REGULATORY INFORMATION DISTRIBUTION SYSTEM (RIDS)

Subject: Palo Verde Nuclear Generating Station (PVNGS)
Units 1, 2, and 3
Docket Nos. STN 50-528/529/530
Response to NRC Comments on Periodic Testing of Alternate AC (AAC)
Sources (Supplementary Safety Evaluation for Station Blackout)
File: 92-001-419; 92-056-026

PERIODIC TESTING OF ALTERNATE AC SOURCES

Plant Layout
Figure 1

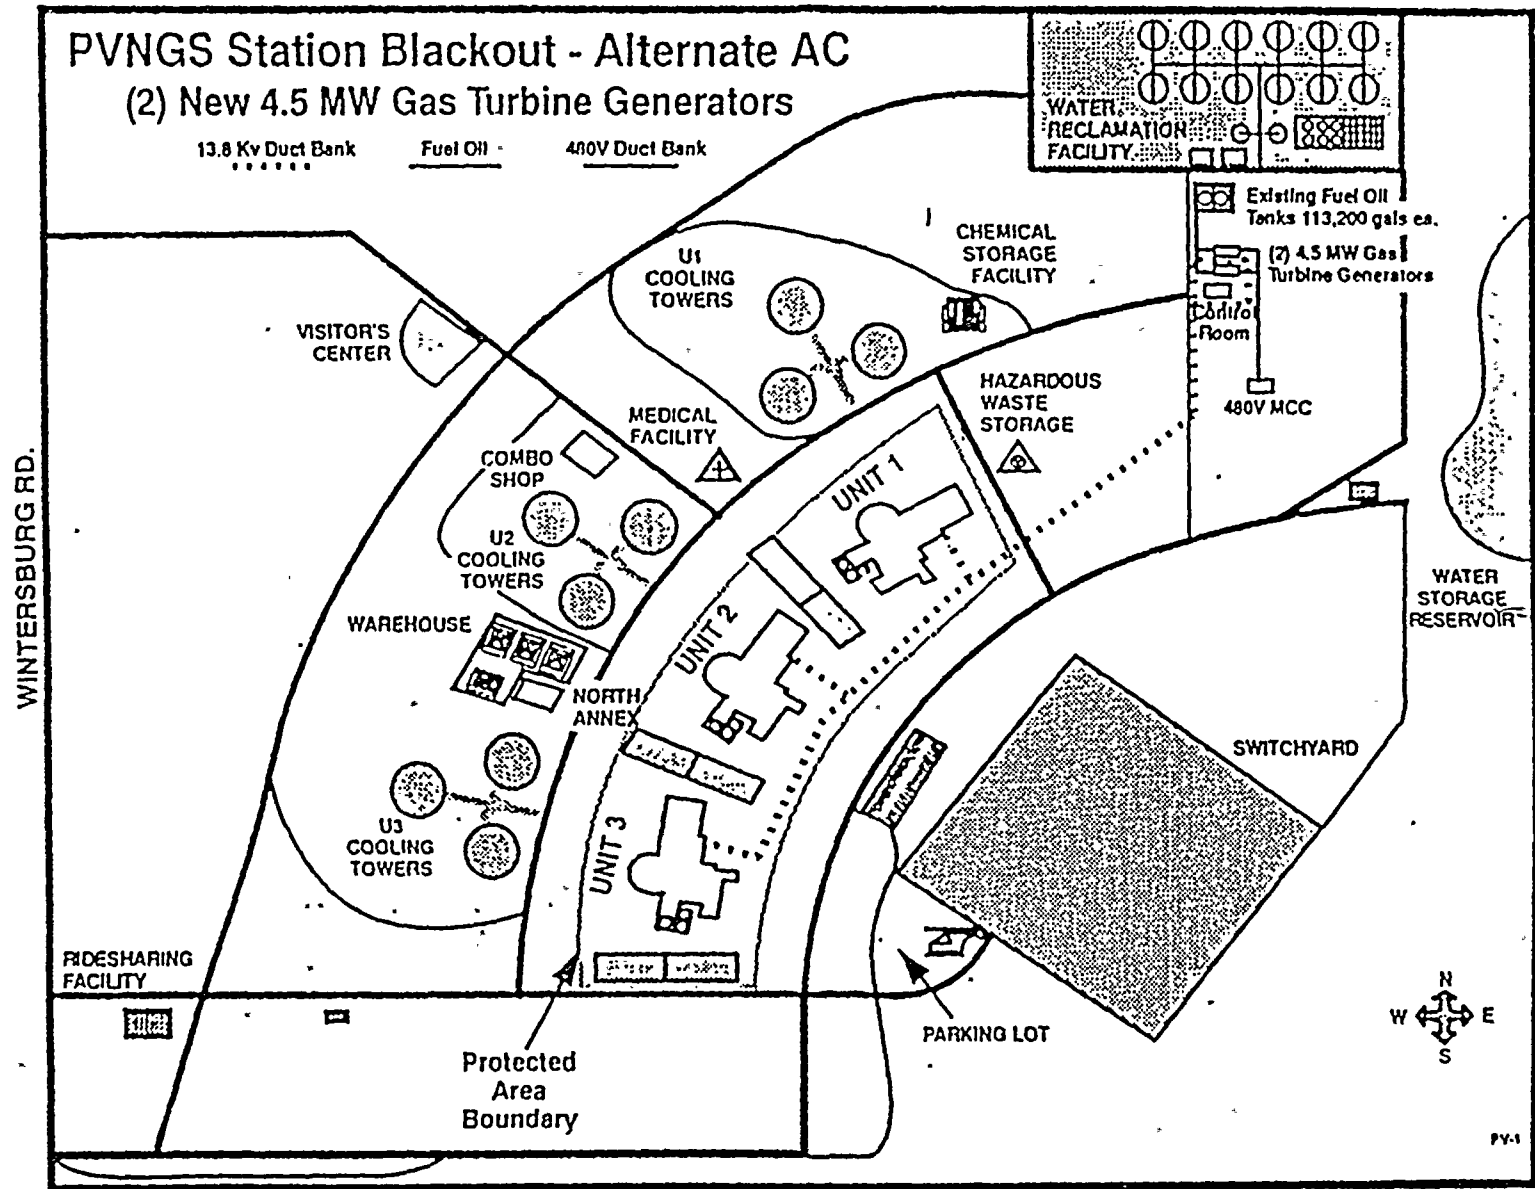
Staff Evaluation: The Staff finds the above licensee's response to be acceptable, except that the operability test at 3-month intervals should include the gas turbine generators being tested under load. NUMARC 87-00, Item B.10, states that the AAC source shall be started and brought to operating conditions that are consistent with its function as an AAC source. The Staff interprets this to mean that the AAC should be load tested to verify that it can meet its intended operability and reliability. Technical Specifications are being considered by the NRC for nonsafety-related SBO equipment which may prescribe further requirements as necessary to verify the operability and reliability of the AAC power source per Reg. Guide 1.155, paragraph 3.3.5, item 5.

The AAC source at Palo Verde Nuclear Generating Station (PVNGS) will consist of two Gas Turbine Generators (GTGs) located outside the PVNGS protected area (see Figure 1). The installation is designed to be used solely as standby generation for the AAC power source and is not intended to be used as a peaking unit. The design of the AAC source provides controls and indication in a local control room located outside the protected area near the GTGs. The design does not include GTG controls or control indication in the PVNGS Control Rooms. This configuration meets the design basis of powering a deenergized plant electrical bus during a SBO event.
